Model: Model S-F2 Date			e: 28-Feb-0	3	No.: MH556002	
Modified Article: Swivel Bracket				Prepared	by: M.	Mano
From: Technical Services Sec. Service Planning Dept.						
Reason for	□ Parts catalog correction	☐ Vend	lor ch	ange	☐ To n	neet standards
Modification: ☐ To facilitate assembly ☐ To improve		e reliability	()		
☐ Part standardization ☐ Other

The following has been changed to improve the reliability of duplex printing.

Modification Bulletin

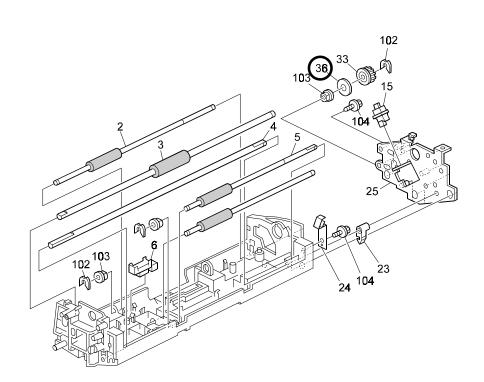
Old part number	New part number	Description	Q'ty	Int	Page	Index	Note
H5564175	H5564179	Swivel Bracket	1	-	27	30

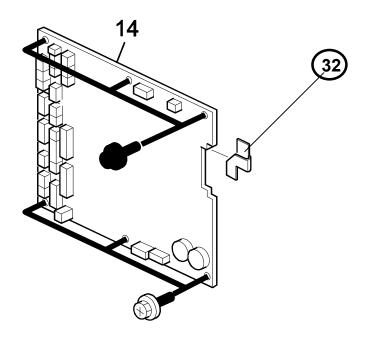
The following has been added to improve the insulation of the FCU board.

Old part number	New part number	Description	Q'ty	Int	Page	Index	Note
-	H5565874	Insulation Sheet	1	ı	29	32

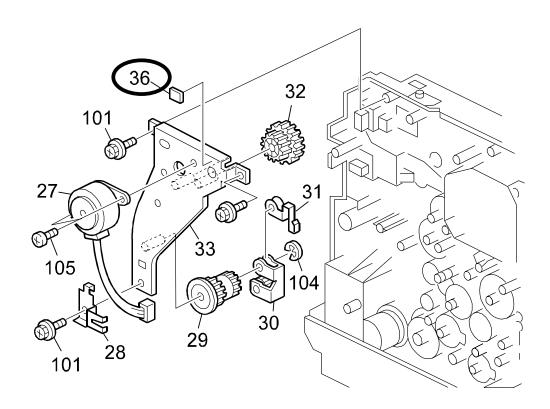
The quantity of the following has been increased by one to further minimize noise from the duplex mechanism.

Part number	Description	Q'ty	Int	Page	Index	Note
B0441139	Damping Insulation	2 → 3	ı	27	36

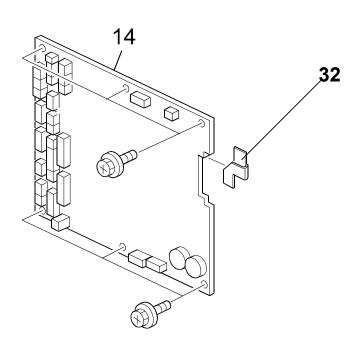
The FCU Board has been changed to further improve its insulation, and the Insulation Sheet was deleted, as this part is no longer necessary.

Old part	New part	Description	Q'ty	Int	Page	Index	Note
number	number						
H5566102	H5566104	FCU Board (120V)	1	X/O	29	14	
H5566103	H5566105	FCU Board (230V)	1	X/O	29	14	
H5565874	ı	Insulation Sheet	1→0	-	29	32

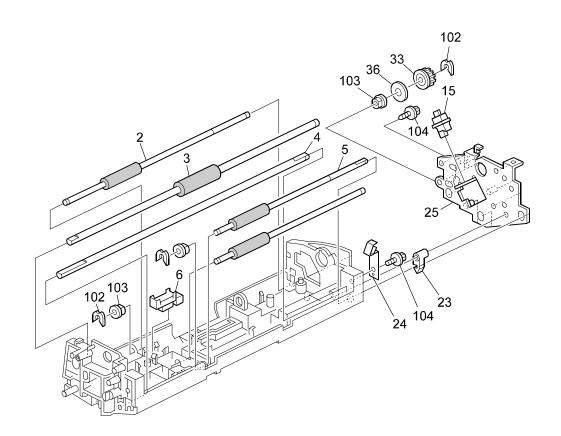
The following has been changed to facilitate installation of the R1 Roller in the field.

Old part	New part	Description	Q'ty	Int	Page	Index	Note
number	number						
H5561257	H5561316	R1 Roller	1	X/O	19	2	
H5561215	1	Spacer	1→0	-	19	36

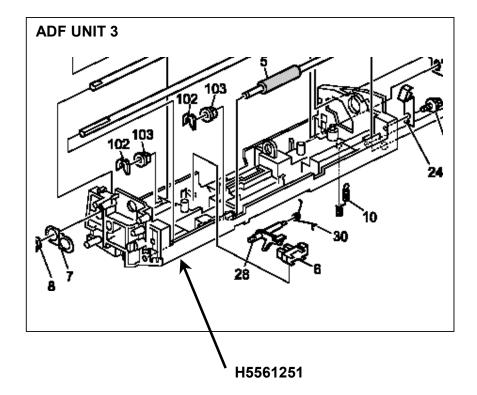
Old part number	New part number	Description	Q'ty	Int	Page	Index	Note
	H5561251	Base	0→1	-/-	19	36

Change: This part was added.

Reason: It was missing from the Parts Catalog.

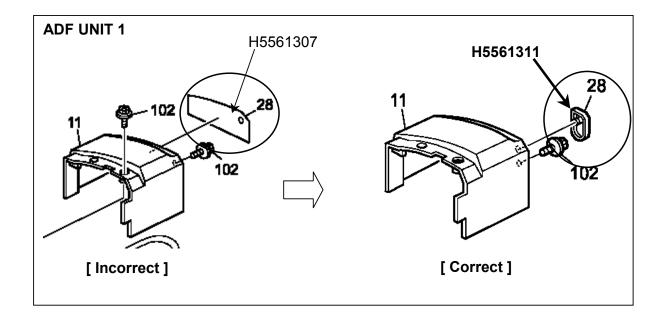
Incorrect	Correct	Description	Q'ty	Int	Page	Index	Note
part number	part number						
H5561307	H5561311	Screw Cap	1→1	-/-	15	28

Change/Reason: The P/N and illustration for this part were corrected.

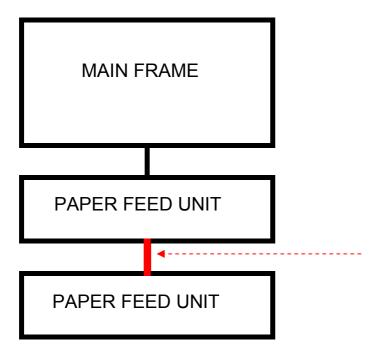
Part Number	Description	Q'ty	Page	Index	Note
H5565241	HARNESS:INTERFACE:LOWER:PALM:ASS'Y	1

Change/Reason: This part was missing from the Parts Catalog.

Note: This harness is used to connect the two Paper Feed Units, as shown below.
